**ALERT SERVICE BULLETIN**

**429-19-47**

**MODEL AFFECTED:** 429

**SUBJECT:** TAIL ROTOR GEARBOX SUPPORT RETAINING RIVETS, INSPECTION OF.

**Figure 1 – Rivet Identification**

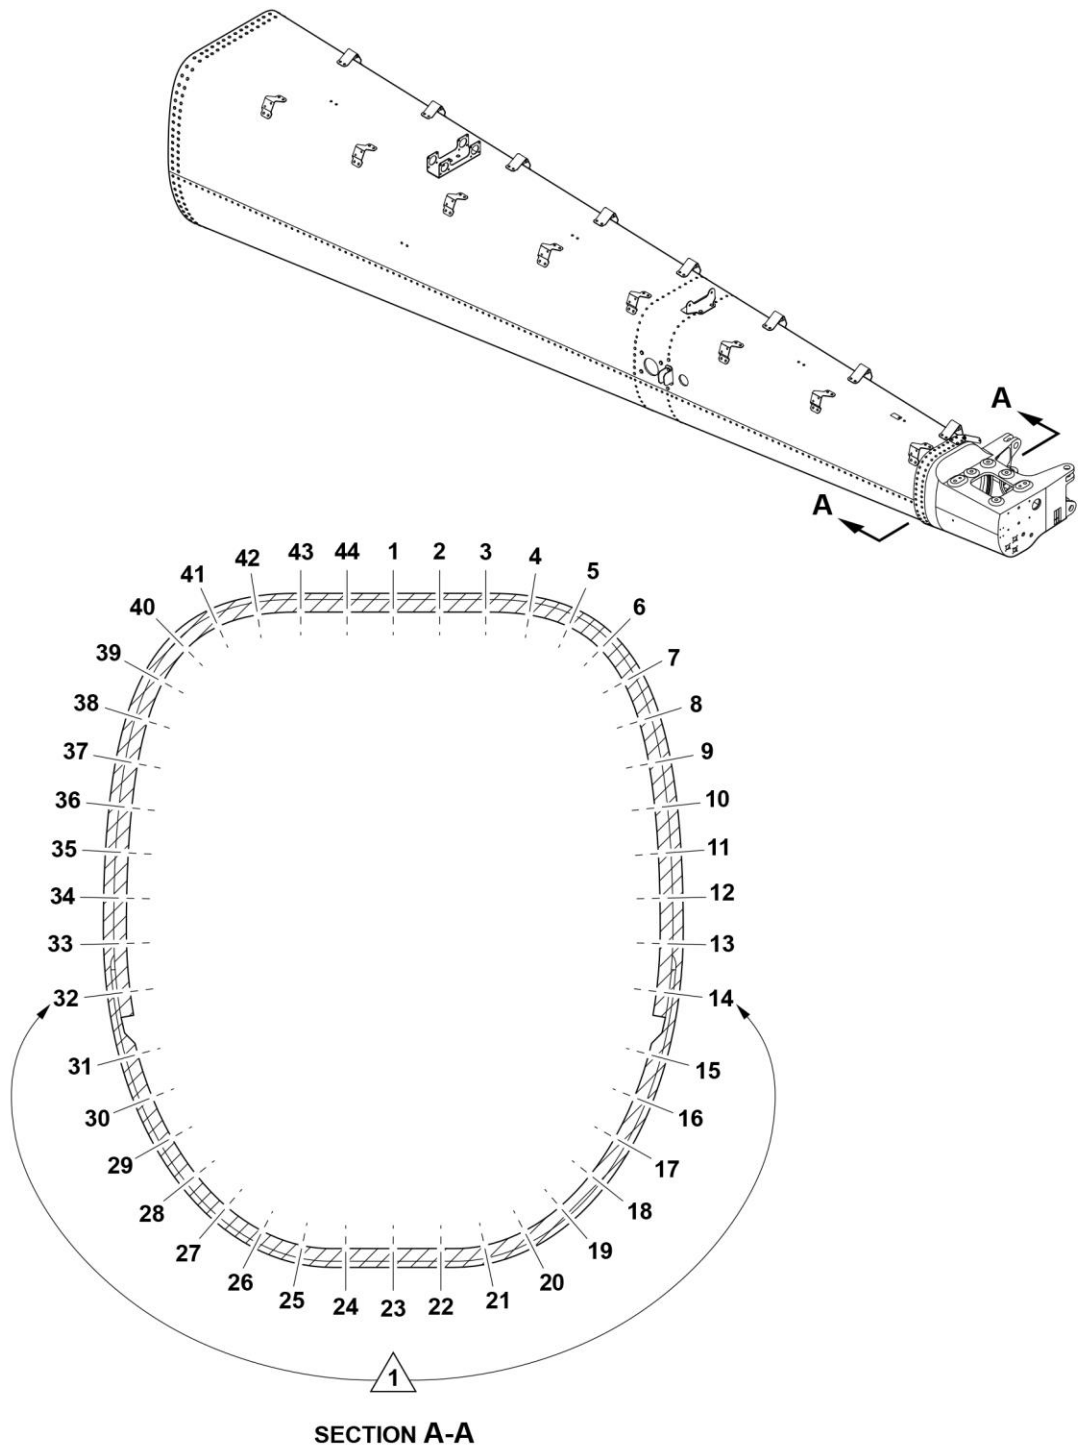
7. Do a tactile check of all the rivets identified in Figure 1 by pulling on each rivet tail.
8. Using Figure 1 to identify the position of the rivets, note the position of any discrepant rivet found during steps 5, 6, and 7 in Table 1.

- (2) If the rivets are failed, proceed to step 9.b.
- b. Remove the edge sealant from the forward edge of the tail rotor gearbox support.
- c. Using a feeler gauge, measure any gaps present between the tail rotor gearbox support and the tailboom skin.

- d. Plot the location of the gaps by using Figure 1 and Table 1.
- e. If no gaps or if gaps measuring 0.005" (0.127 mm) or less are found, replace the discrepant rivets per BHT-ALL-SRM, Chapter 3 and proceed to step 10. If gaps in excess of 0.005" (0.127 mm) are present, proceed to the next step.

Perform tactile check on indicated rivet tails.
